SCDC Planning Reference S/3440/18/OL**Bourn Parish Council Response to outline planning permission for a new mixed-use village comprising residential development of approximately 3,500 dwellings.**

Figure 15 – Schematic Proposed Bus Network

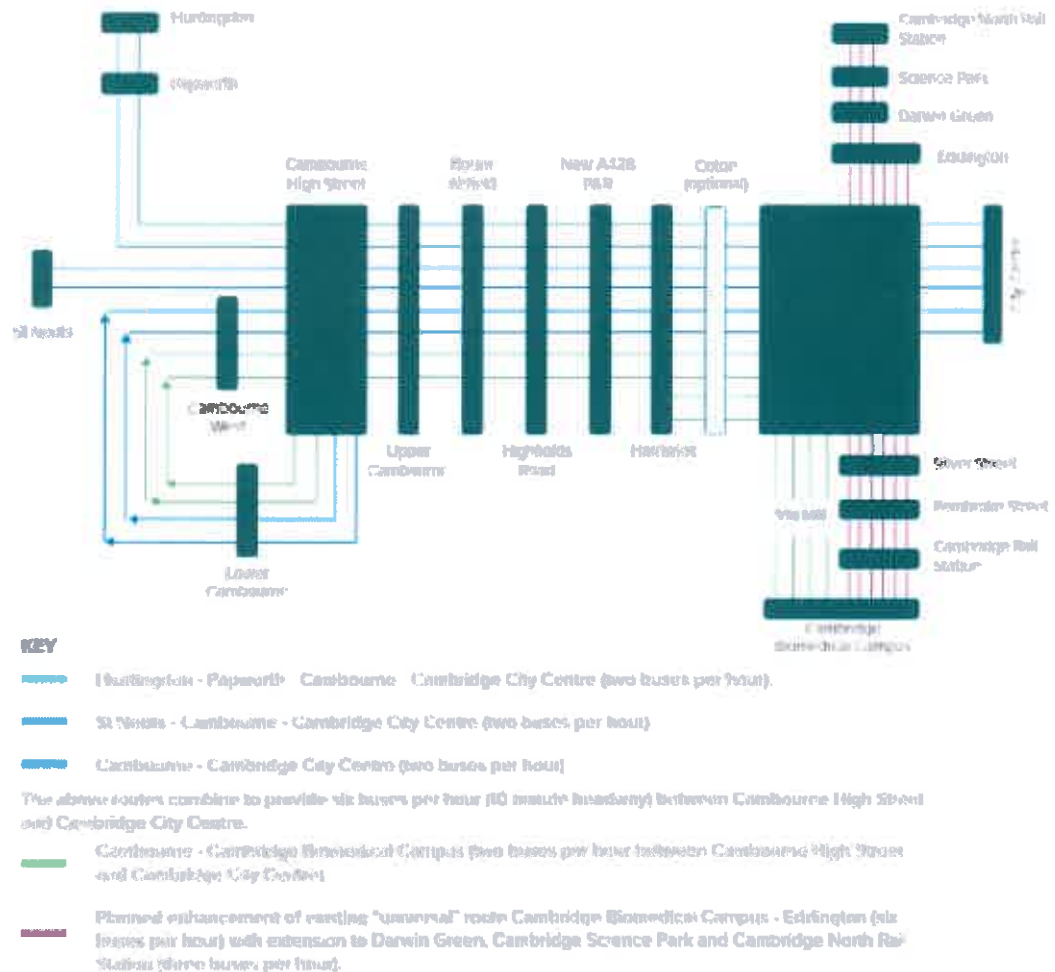
The GCP are proposing 8 buses an hour - only three fewer than our notional target of 11. However, 4 of the 8 buses have come from other towns and will not be empty. We must assume that the buses from St Neots and Huntingdon will arrive in Cambourne already laden with passengers. In addition, what provision is made for passengers expecting to board the buses at the new A428 P&R? The numbers don't add up. You can't transport 2,077 passengers originating in West Cambourne, Cambourne and Bourn Airfield to either Cambridge, or the Biomedical Campus, with 8 buses and an hour when half the buses are also serving St. Neots, Huntingdon, Papworth and the new park & ride. Neither the applicant, nor the Greater Cambridge Partnership, are being open and honest about what level of modal shift the busway can achieve.

What is clear is that the GCPs current Network Schematic for the C2C busway falls far short of being able to transport 2,077 passengers from the three A428 sites into either Cambridge, or the Biomedical Campus.

**“All arms” Mott Mac record Nov 2018 ** Base Flow Model Test 6 AM Peak hour estimates from BAD. The base vehicle flow AM peak 08:00 to 09:00

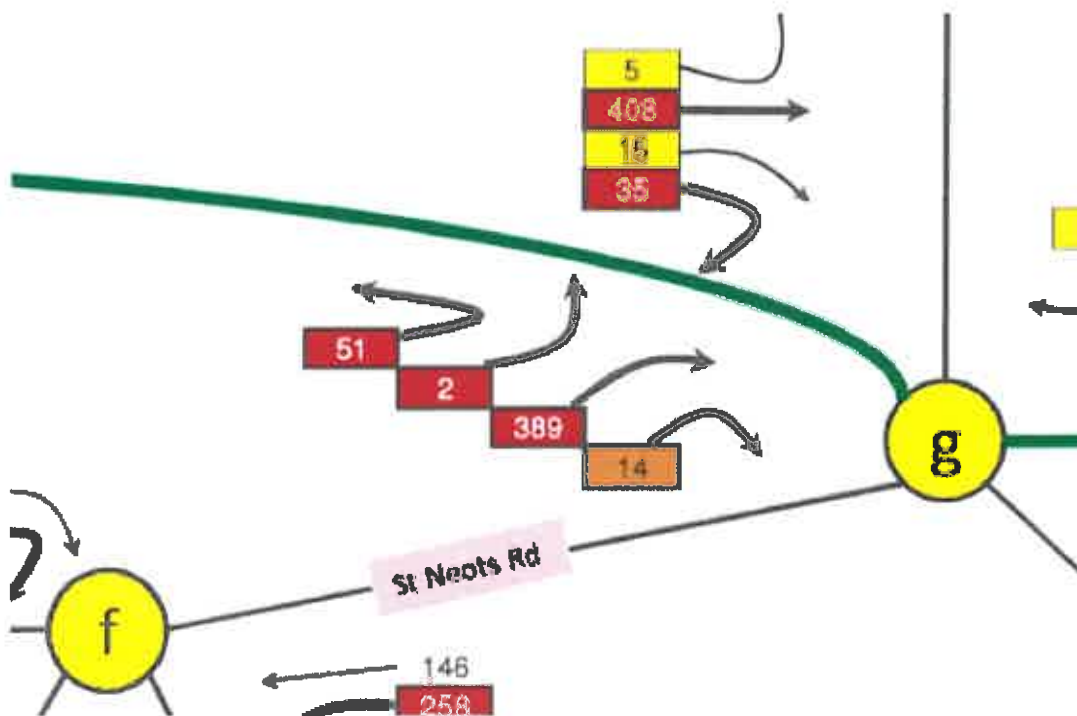
We are unhappy with the inadequate traffic estimates in the base flow models provided in the applicant's transport assessment. Many of the data points are unclear with no reasons given for the distribution at each junction. In addition, the base flow models have no legends and interpretation is therefore severely hindered. For example, we rigorously dispute the estimates for traffic flow into Hardwick on the St Neots Road. We also question why there is no explanation given for the traffic consultants' decision to predict that a significant proportion of traffic will exit Bourn Airfield via the east exit at Childerley roundabout but will then travel west. The applicant consultants are suggesting that only 52% of Bourn Airfield traffic will head east. This figure is in direct conflict with the latest Cambourne figure which recorded eastbound traffic at 77%.

The table below, and the accompanying junction analysis graphic, show the potential discrepancies. We know from the 'All Arms' Mott MacDonald records of November 2018, that 459 cars arrive at the Hardwick roundabout from the St Neots Road. The TSP and TRICS data suggest the traffic generated by Bourn Airfield will mean that an additional 350 (TSP based prediction), or 283 (TRICS based prediction), will join those 459 cars going on to the St. Neots Road. Of the 459 cars registered in the Mott MacDonald data, 188 go into Hardwick village. That would mean that based on the TTSP (and TRICS) data, Bourn Airfield would generate an additional 143 (or 116) cars entering Hardwick village in the morning peak hour 08.00 – 0900. Bizarrely, the Bourn Airfield Traffic Assessment predicts that additional number at only 14 cars. It's clear that these numbers need to be properly interrogated.

Recommendation 3: The applicant should be asked to review and revise the assumed traffic flows affecting the surrounding villages.
